# Access Compliance Report

## Public Rights-of-Way

### (Curb Ramps)

Intersection ID: 49790	Main Street: FESCUE_CT	Cross Street: BARLEY_LN	Location:	E
ADA ID: DEC8040D9077	Ramp Type: Perp	Initial Pass/Fail: Fail	Overall Compliance: No	Severity Score: 8.75

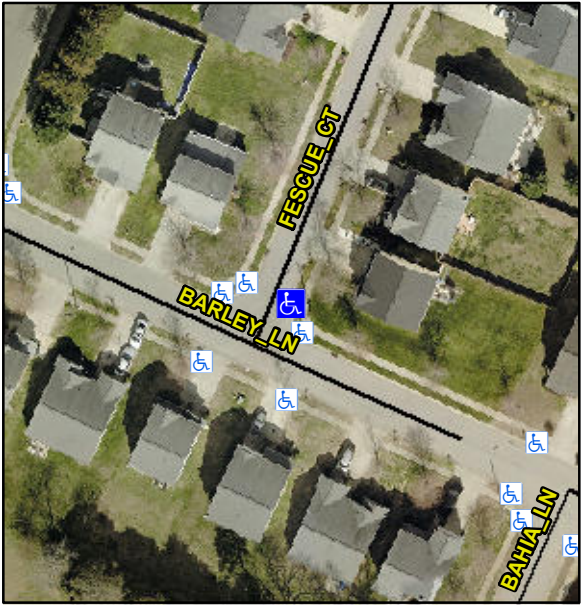
Codes/Mitigation Info/Possible Solution			Field Measurements/Component Compliance		
	Possible Solutions:		<b>Compliance</b>	<b>Description</b>	<b>Data</b>
	<b>Remove &amp; Replace Entire Ramp.</b>		<b>Yes</b>	Ramp Length (in)	47.5
			<b>No</b>	Ramp Width (in)	47.0
			<b>N/A</b>	Flare Type LT	N/A
			<b>N/A</b>	Flare Slope LT (%)	N/A
			<b>N/A</b>	Flare Traversable LT?	N/A
			<b>N/A</b>	Landing Length (in)	N/A
			<b>N/A</b>	Landing Width (in)	N/A
			<b>N/A</b>	Landing Slope (%)	N/A
			<b>N/A</b>	Landing X Slope (%)	N/A
<p>Surveyor Notes:</p> <p><b>N/A</b></p> <p>PROW/ADA:</p> <p><b>Not Found, R304.5.1</b></p>			<b>N/A</b>	Flare Type RT	N/A
			<b>N/A</b>	Flare Slope RT (%)	N/A
			<b>N/A</b>	Flare Traversable RT?	N/A
			<b>N/A</b>	DWS Provided?	N/A
			<b>N/A</b>	DWS Contrast?	N/A
			<b>N/A</b>	DWS Length (in)	N/A
			<b>N/A</b>	DWS Full Width?	N/A
			<b>N/A</b>	DWS Offset (in)	N/A
			<b>N/A</b>	Shared Landing?	N/A

<b>N/A</b>	Gutter Ponding?	N/A
			<b>N/A</b>	Gutter Lip Ht (in)	N/A
			<b>N/A</b>	Painted X Walk1?	No
				X Walk 1 Direction	To NW
			<b>N/A</b>	X Walk 1 Width (in)	N/A
				X Walk 1 Slope (%)	2.5
				X Walk 1 X Slope (%)	3.0
			<b>N/A</b>	Ramp inside XWalk1?	N/A
			<b>N/A</b>	Road Slope (%)	N/A
			<b>N/A</b>	Road X Slope (%)	N/A
			<b>N/A</b>	Any Obstructions?	N/A
				Obstruction Type	
			<b>N/A</b>		
			<b>N/A</b>		
			<b>N/A</b>		
			<b>N/A</b>		
			<b>N/A</b>		
			<b>N/A</b>		
			<b>N/A</b>		
			<b>N/A</b>		
			<b>N/A</b>		
Total Cost:		\$ 1850.00			
			<b>Yes</b>	Surface Condition? (G/P)	Good
